QUALITY ASSURANCE -- NON-CONFORMANCE REPORT

Report No: NCR-000688

Reference Description: OBG Segment 6AE FL3 at PP39 was damaged during the transportation of the Crossbeam

To:	AMERICAN BRIDGE/FLUOR, A JV 375 BURMA ROAD OAKLAND CA 95607	Date:	26-Feb-2010
Dear:	Mr. Charles Kanapicki	Contract No:	04-0120F4 04-SF-80-13.2 / 13.9
Attention:	Mr. Thomas Nilsson Project/Fabrication Manager	Job Name:	SAS Superstructure
Subject:	NCR No. ZPMC-0655	Document No:	05.03.06-000645

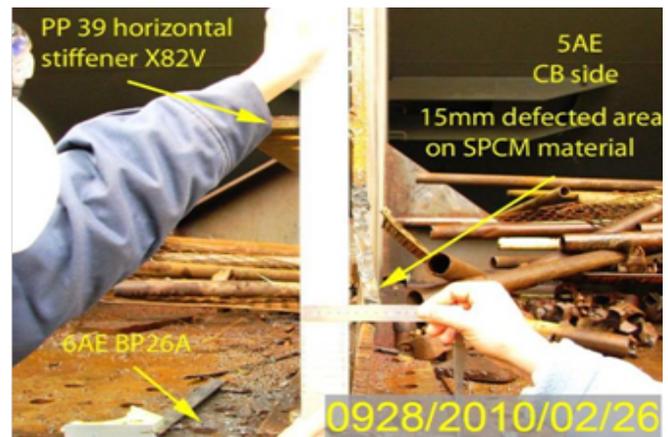
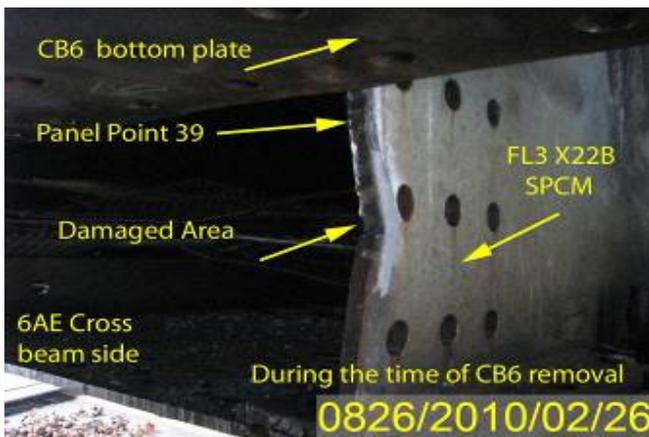
- One (1) damaged/bent FL3 plate member damaged at panel point (PP) 39 at Segment 6AE.
- The damaged plate is designated as X22B
- Length of deflected area is over approximately 250mm in length at the lower portion of the plate.
- The maximum deflection of 15mm is measured using a 1000mm straight edge.
- The steel material is designated as Seismic Performance Critical Member (SPCM).
- The OBG 6AE segment is located at the Trial Assembly yard.

ZPMC has repaired the floorbeam with heat straightening and is providing the heat straightening report used and the hardness testing results after to show that the base metal is acceptable. These results have been accepted my CT METS. Based on this ZPMC requests closure of this NCR.

This proposed resolution is acceptable. The documentation received is sufficient and the Department concurs that Non-Conformance ZPMC-0655 is closed.

Reference Description: OBG Segment 6AE FL3 at PP39 was damaged during the transportation of the Crossbeam

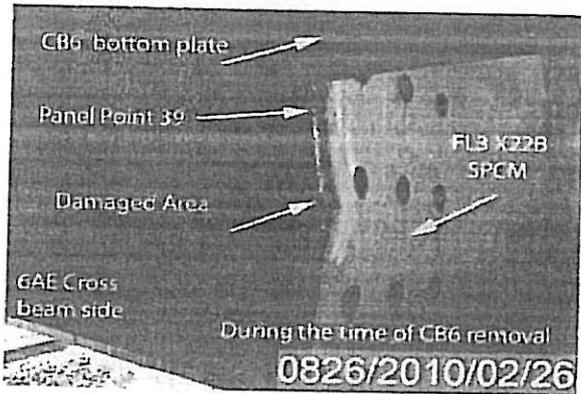
- One (1) damaged/bent FL3 plate member damaged at panel point (PP) 39 at Segment 6AE.
- The damaged plate is designated as X22B
- Length of deflected area is over approximately 250mm in length at the lower portion of the plate.
- The maximum deflection of 15mm is measured using a 1000mm straight edge.
- The steel material is designated as Seismic Performance Critical Member (SPCM).
- The OBG 6AE segment is located at the Trial Assembly yard.

Heat Straightening Report(HSR)

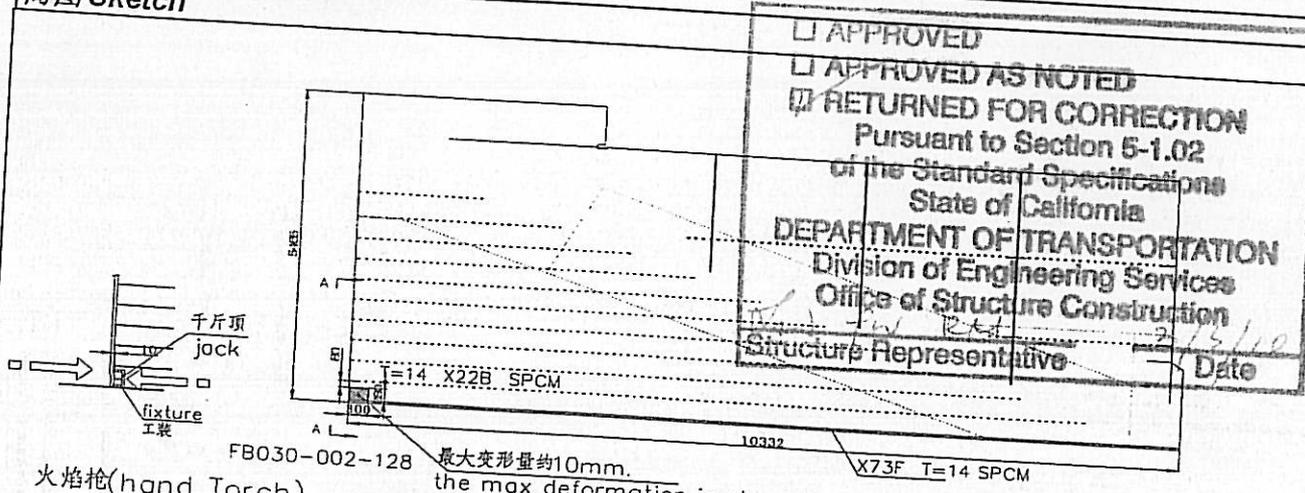
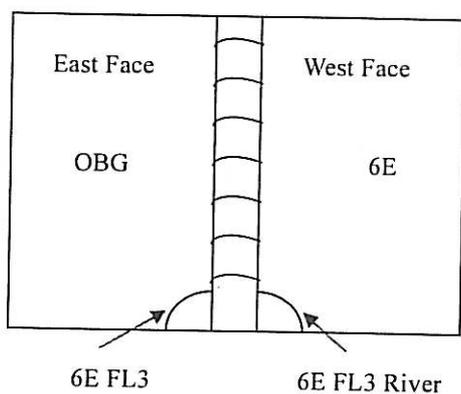
FB030-002-128 最大变形量约 10mm.
 the max deformation is about 10mm.
 注: 最大变形量约 10mm, 用千斤顶将焊接变形量顶到位, 固定不动, 再进行火工校正。
 NOTE: the max deformation is about 10mm, Correct the welding distortion by use of jacking, and then perform heat straightening with the jack still on the flange plate.

Jacking shall not be used to plastically deform the flange. The Jack shall only be used as a fixture. The weld of the heat area shall perform 100%VT, MT, UT after finishing heat straightening, according to the approved shop drawing. 不能使用千斤顶进行塑性变形。千斤顶只能用作固定装置。校火后需按照图纸上的要求对热影响区域进行 100%VT, MT, UT 检测。

Increase the flange anti-deformation allowance during the course of fit-up, and Control the welding parameters according to associated WPS. 在装配的过程中增加反变形余量。根据相关 WPS 控制焊接参数。

Hardness Testing Report Rev. 2

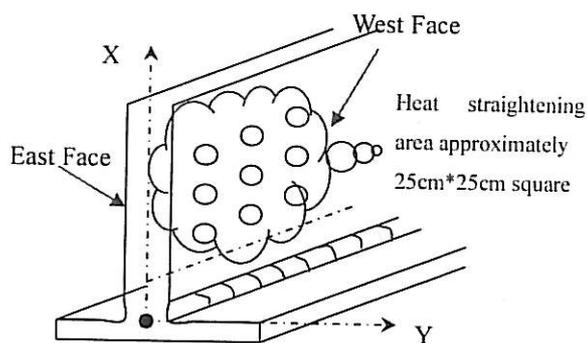
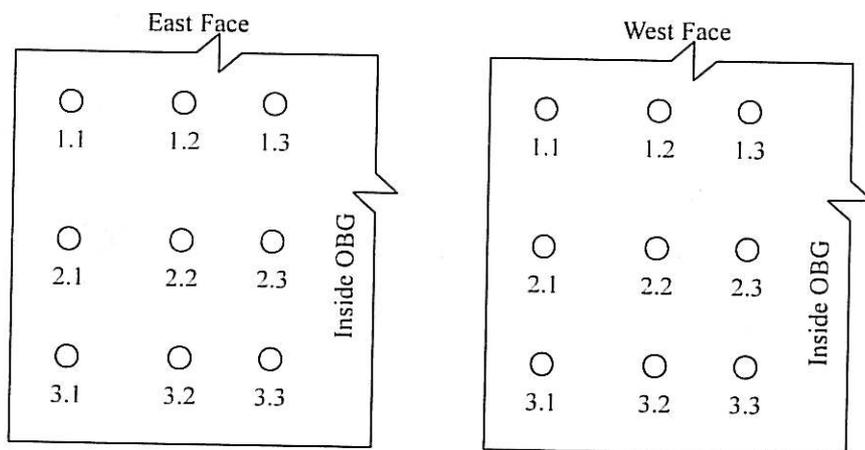
6E FL3 Hardness Test Result						
Hardness Tester Type: TH140						
Location	6E FL3 (East Face)			6E FL3 (West Face)		
	X	Y	Hardness	X	Y	Hardness
1.1	29cm	5cm	143 HB	29cm	5cm	143 HB
1.2	18cm	12.5cm	190 HB	18cm	12.5cm	159 HB
1.3	6.5cm	21cm	162 HB	6.5cm	21cm	175 HB
2.1	29cm	5cm	153 HB	29cm	5cm	151 HB
2.2	18cm	12.5cm	155 HB	18cm	12.5cm	180 HB
2.3	6.5cm	21cm	153 HB	6.5cm	21cm	174 HB
3.1	29cm	5cm	197 HB	29cm	5cm	154 HB
3.2	18cm	12.5cm	176 HB	18cm	12.5cm	170 HB
3.3	6.5cm	21cm	176 HB	6.5cm	21cm	160 HB

Contractor provided results of hardness tests verifying material affected by heat straightening conforms with Contract hardness requirements.
